Aeronautical Charting Forum 14-01

April 29, 2014

AERONAUTICAL CHARTING FORUM (ACF)

INSTRUMENT PROCEDURES GROUP (IPG) AGENDA

V-343/JOXIT Feeder WP, Dillon, Montana

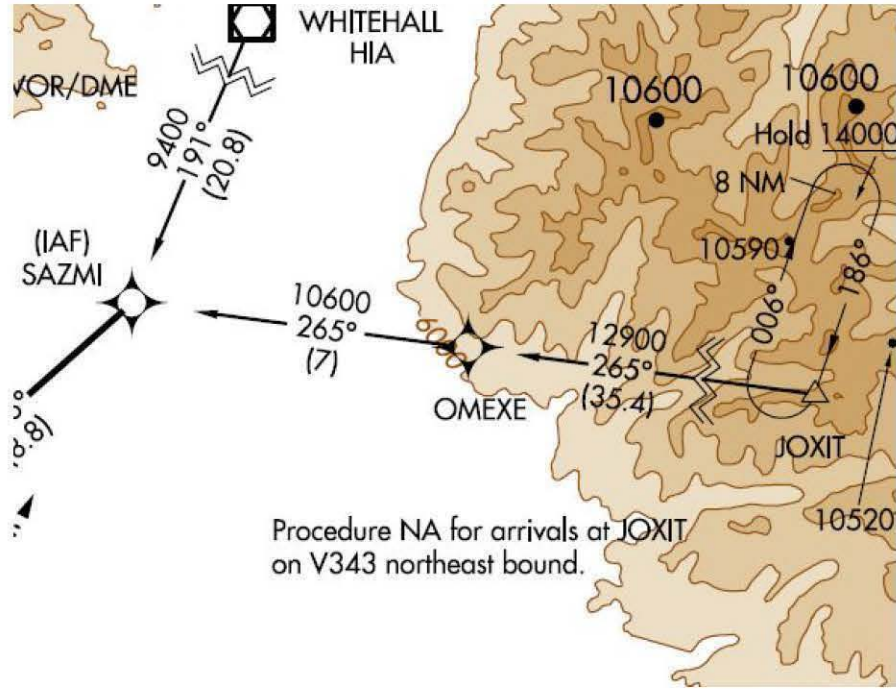
A recently implemented example is on the Dillon, Montana (KDLN) RNAV (GPS) Runway 17 SIAP, for an arrival on Victor Airway 343 from the south (illustrated in the attachment)*. Note that the course change from V-343 northbound onto the JOXIT feeder route is 101 degrees and prohibited by the JOXIT note. Instead, the JOXIT arrival holding pattern shown on the approach chart is an implicit course reversal to permit entry onto the JOXIT feeder route arriving on V-343 from the south.

*Note: A very recent change to V343 removed JOXIT from the airway structure. However, the issue remains since the limitation is reflected on SIAP chart and is found on other procedures within the NAS.

Recommendations: AFS-420 should commission a simulation study of both the 90 degree and 120 degree turn limits when RNAV equipment is used to navigate an airway-to-feeder route segment. The study should also evaluate the performance of RNAV systems when an arrival hold is used in lieu of a larger turn angle limit, and in particular the RNAV system performance leaving the holding fix (which are often treated as “fly-by” waypoint when exiting the hold) and joining the feeder route. NBAA believes such simulations will validate that a 120 degree course change is far preferable to an arrival hold “course reversal.”

If the FAA determines that it must retain the limit on airway to feeder (or initial segment) RNAV SIAPs to 90 degrees because of RNAV system performance, then consideration should be given to placing the same limit non-RNAV SIAPs since today RNAV systems are largely used to navigate these routes in lieu of the ground-based NAVAID. In addition, definitive, comprehensive policy needs to be provided to AeroNav Services that gives objective guidance about when arrival holding patterns must be included in original or revised RNAV and ground-based SIAPs. Consideration should also be given to establishing speed limitations on SIAPs that will allow the use of RNAV systems while supporting the existing 120 degree turn angle limit.

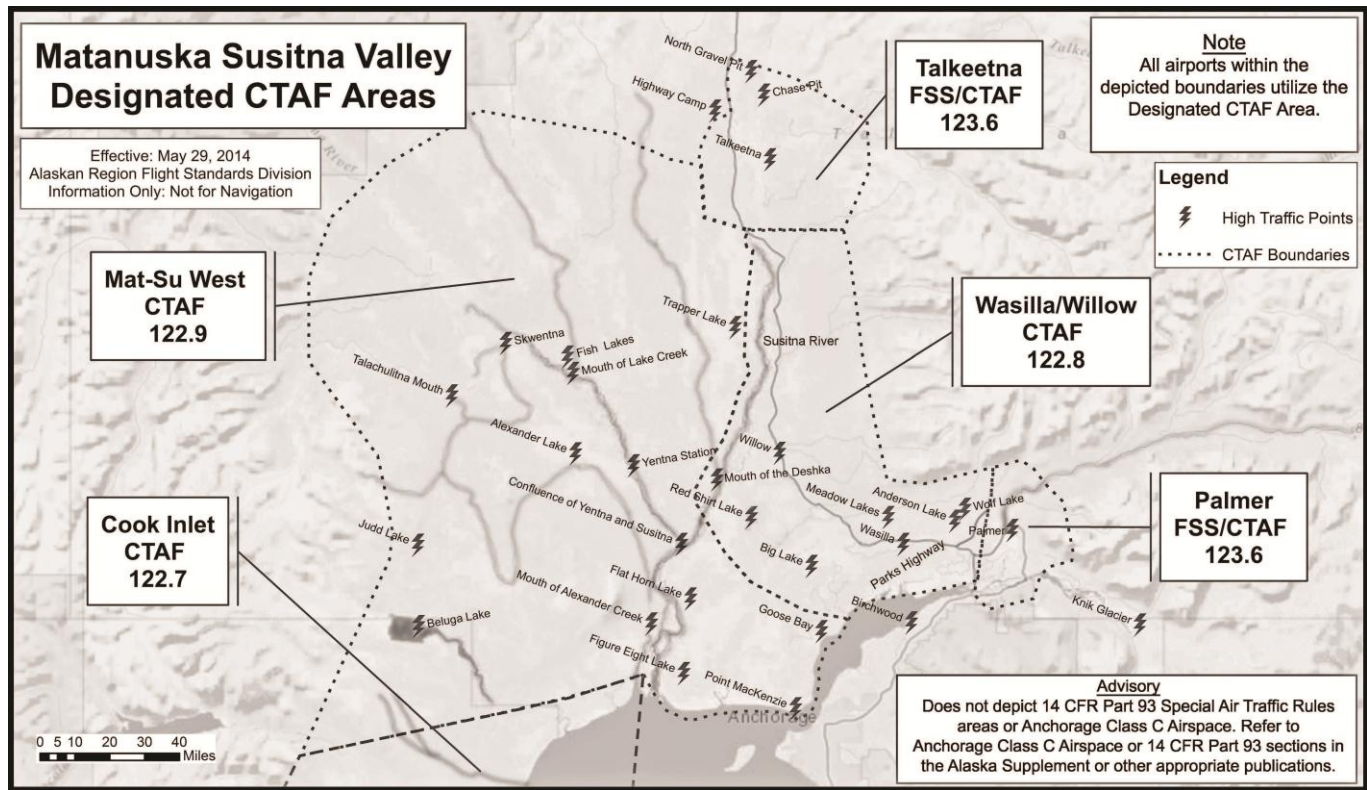
NTSB findings recently included a review of the CTAF frequencies used in the area around several accident sites and revealed the use of multiple primary radio frequencies, but due to the high concentration of aerodromes in the area, many of the frequency boundaries overlap.

We recommend that charting conventions and symbology be developed to show CTAF Area boundaries for aeronautical charts in order to provide consistent CTAF information for airmen. This methodology should lead to a reduction in near mid-air collision by eliminating conflicting, confusing guidance and provides for easily accessible information. Conventions need to apply both to printed and electronic charts.

AWOS-3PT BPC as Stand Alone at Private Use Airport Mesa Vista Airport (PVT) TX13

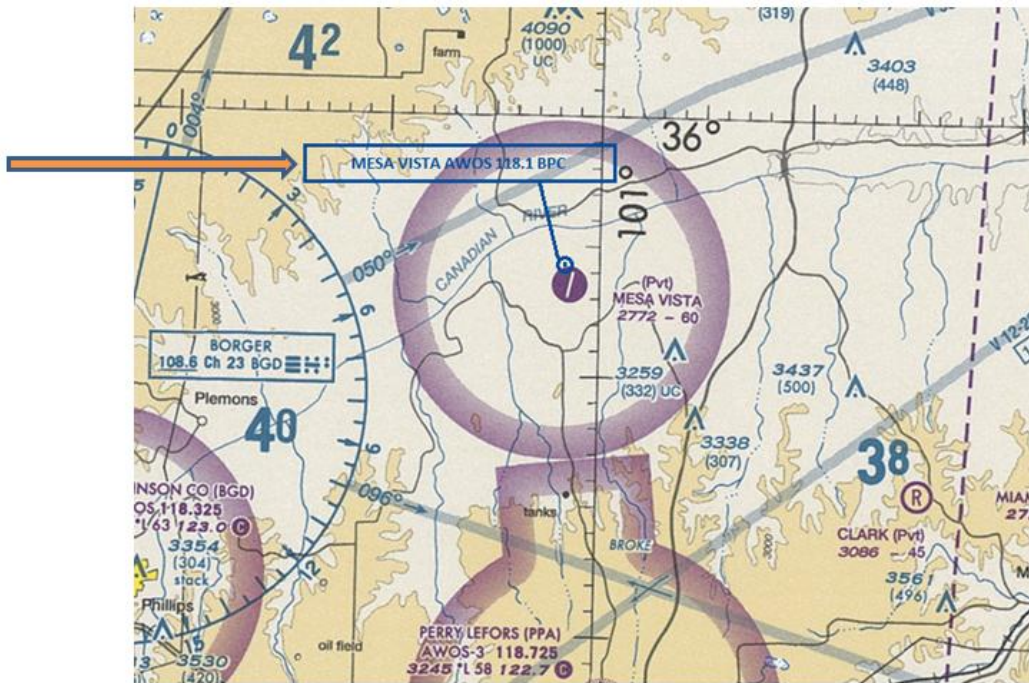
**This configuration currently exists, however BPC is not charted or printed to the A/F D

Assign a three character FAA identifier to the weather system that is independent of the four character private use airport identifier.

Treat the weather sensor as if it is a standalone facility.
